**SECTION 00 91 03  
ADDENDUM NUMBER 3**

**DATE:** MARCH 6, 2020

**PROJECT:** CITY OF AURORA - CITY CLERK AND BUDGET DEPARTMENT  
RENOVATION  
44 E. DOWNER PLACE  
AURORA, ILLINOIS 60507

**PROJECT NO:** 19-130-1267

### **4.02 DRAWING A310 - FIRST FLOOR & REFLECTED CEILING PLAN**

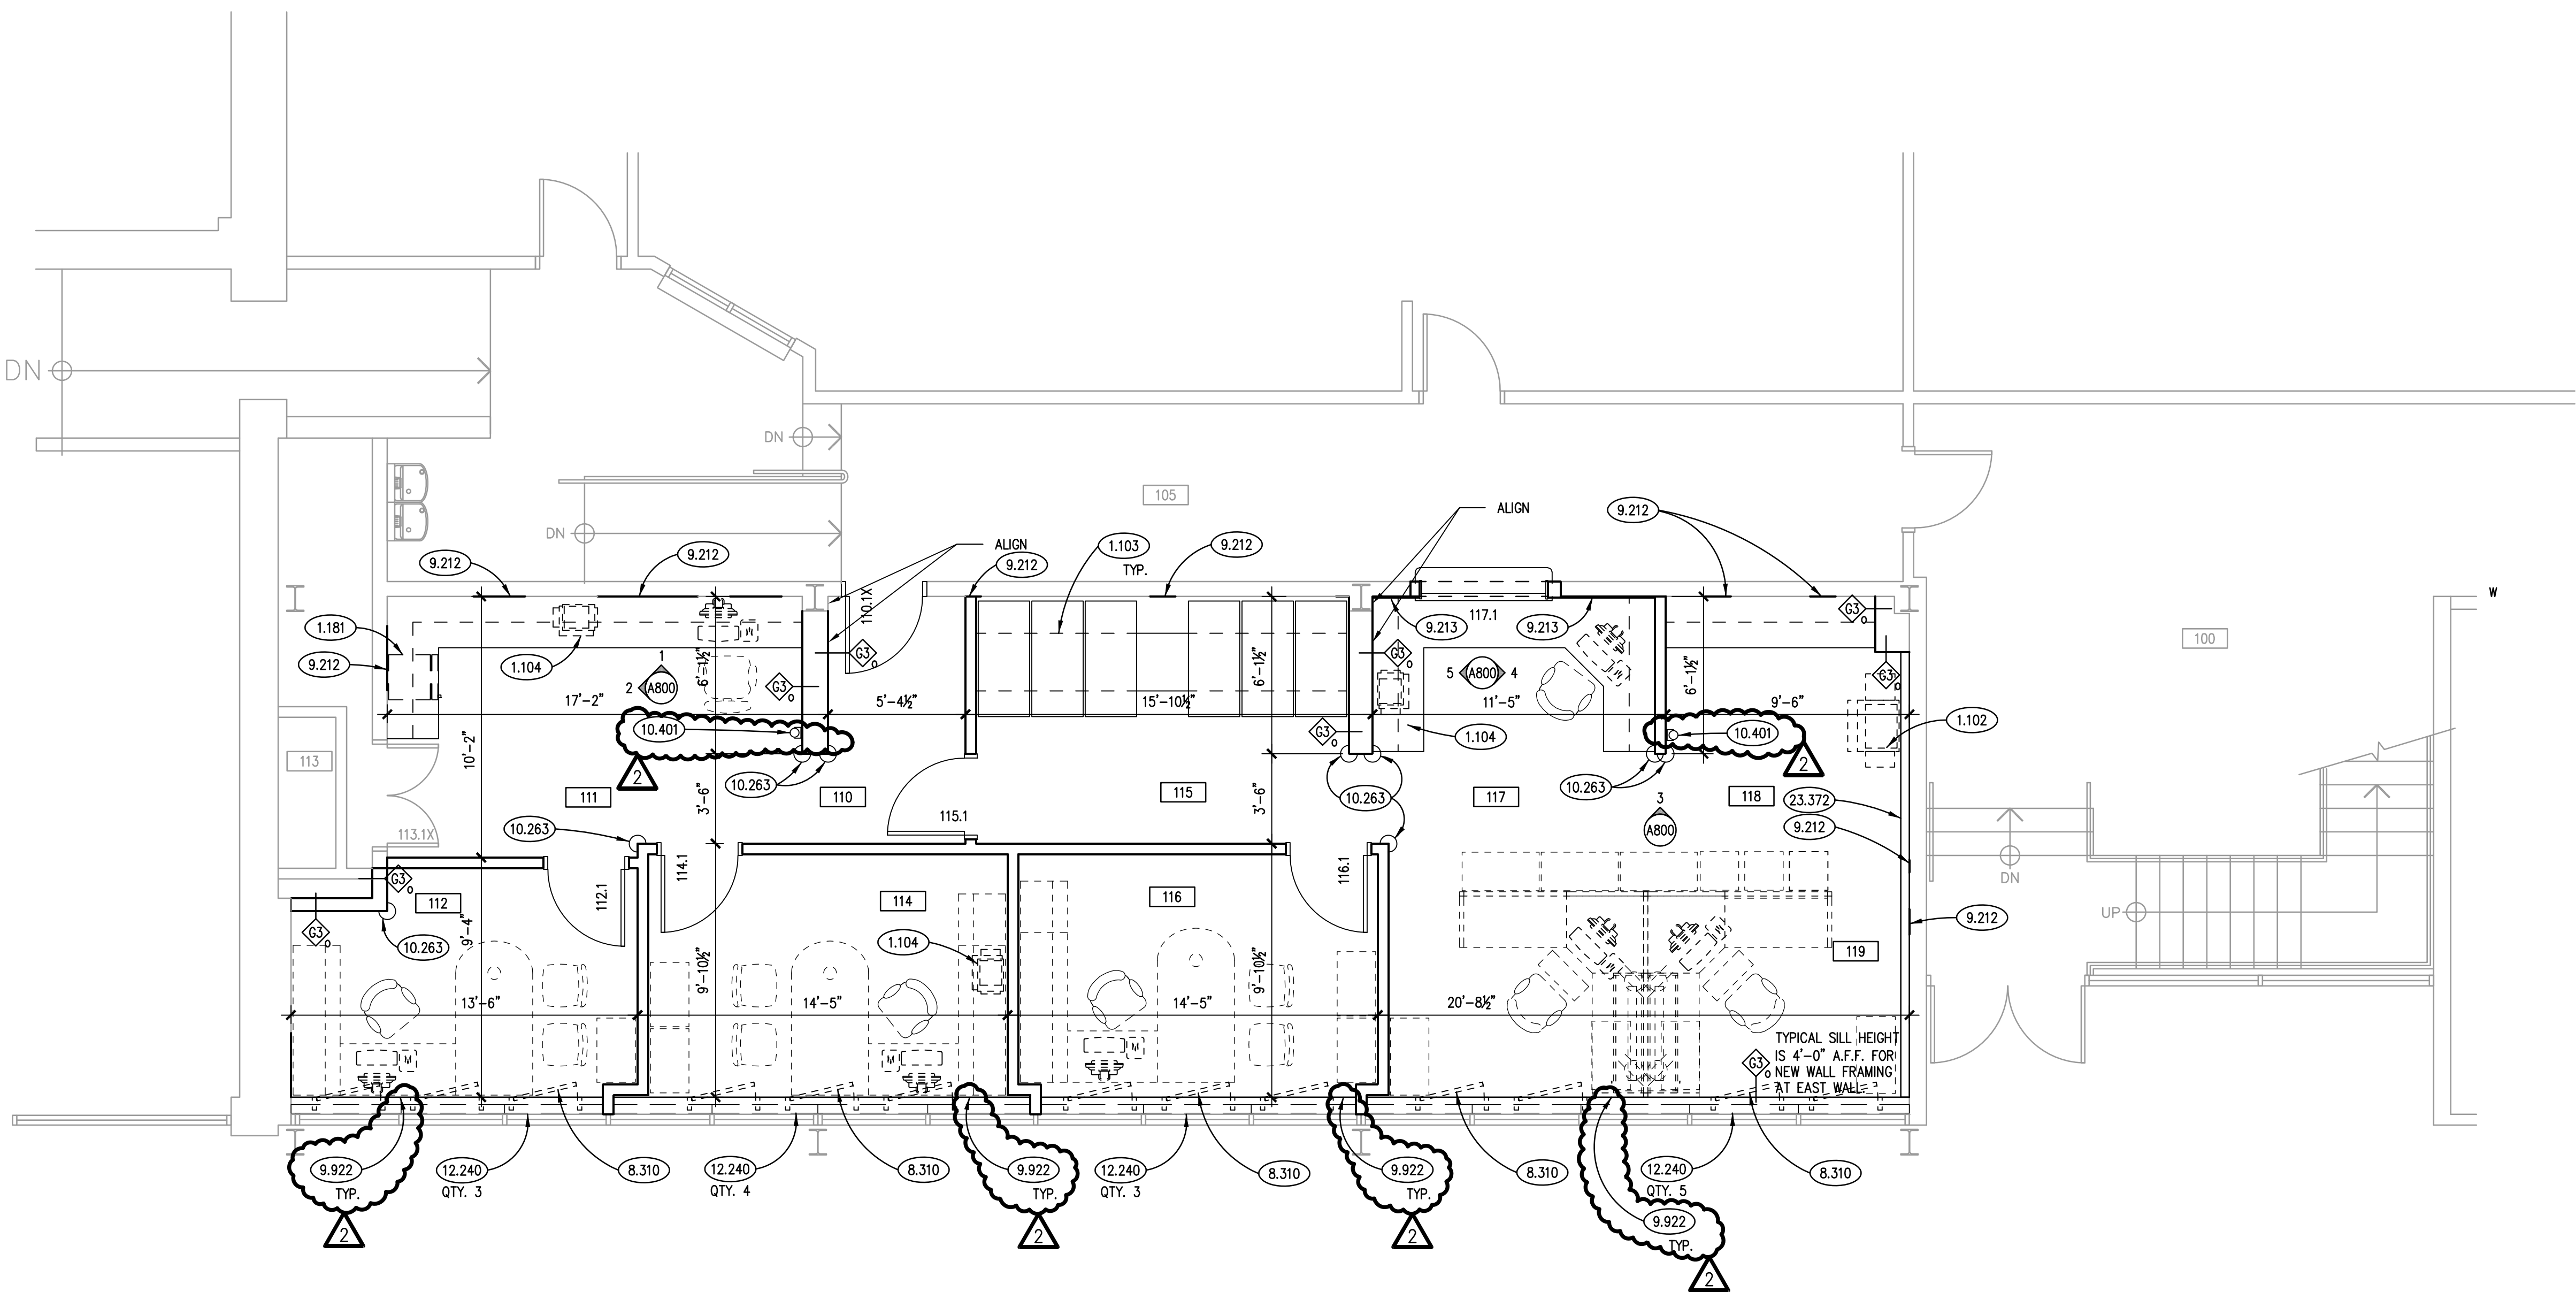
- A. Added two fire extinguishers and wall brackets. Refer to Keynote 10.401 and drawing Rooms 111 & 118. See attached re-issued Sheet A310 reflecting these revisions.
- B. Added Keynote to address re-painted of the existing window sill. See re-issued Sheet A310.

### **4.03 DRAWING A800 - DOOR, FRAME & HARDWARE SCHEDULES, ROOM FINISH SCHEDULE, INTERIOR ELEVATIONS**

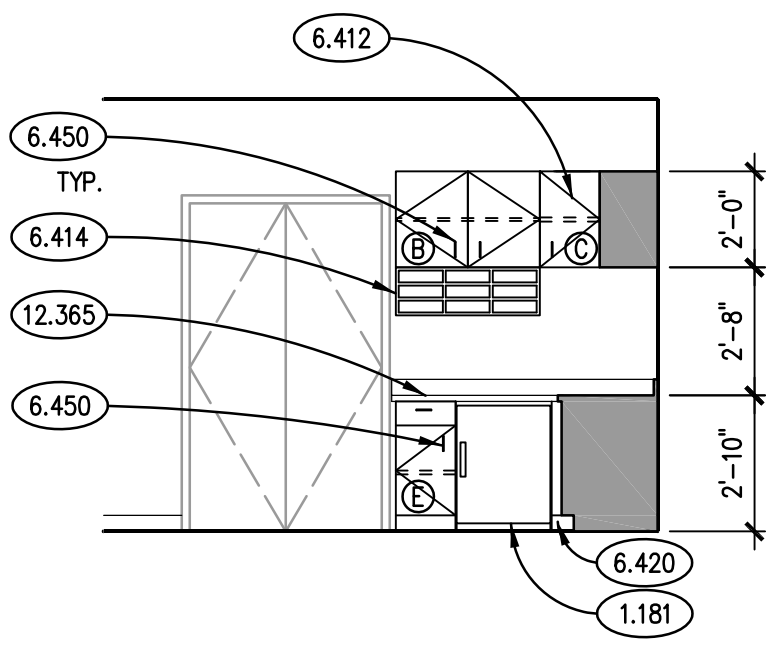
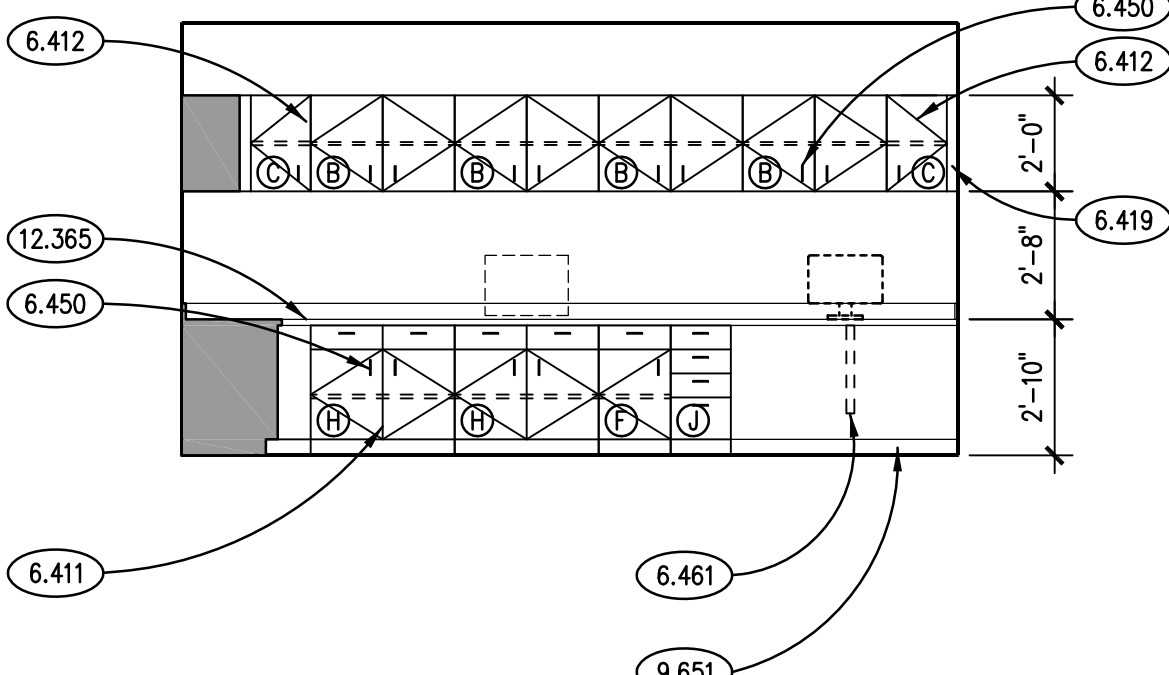
- A. Detail 3: Revised height of transaction countertop to be 3'-0" AFF and enlarged transaction window size.
- B. Frame Types: Revised size of Frame Type 2. Revised height above finished floor to bottom of window to be 3'-0". Revised window frame height to be 4'-2".
- C. See attached re-issued Sheet A800 reflecting these revisions.
